REMARKS

Briefly, applicant's invention is a three-dimensional (3-D) interactive display system, display and a method of forming the same. A transparent capaciflector (TC) camera is formed on a transparent shield layer on the screen surface. A first dielectric layer is formed on the shield layer. A first wire layer is formed on the first dielectric layer, wires on the first wire layer run in a first direction. A second dielectric layer is formed on the first wire layer. A second wire layer is formed on the second dielectric layer, wires on said second wire layer are orthogonal to wires on the first wire layer. The TC camera is protected by a surface dielectric layer. Wires on the first wire layer and second wire layer are grouped into groups of parallel wires with a turnaround at one end of each group of parallel wires and a sensor pad at the opposite end. Each group of parallel wires includes five silver wires spaced a half a centimeter apart.

12/12

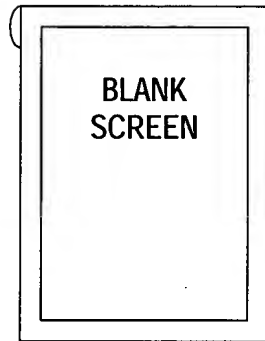
Examiner has objected to the drawings as failing to comply with 37 CFR 1.84(p)(5) because sheet 12 included a reference sign (10A) not mentioned in the specification. Applicant has corrected sheet 12 to include the reference sign 12A so as to be consistent with the description in the specification. A replacement drawing sheet 12, which includes the correction, is hereby submitted. Thus the drawings have been corrected so as to comply with 37 CFR 1.84(p)(5).
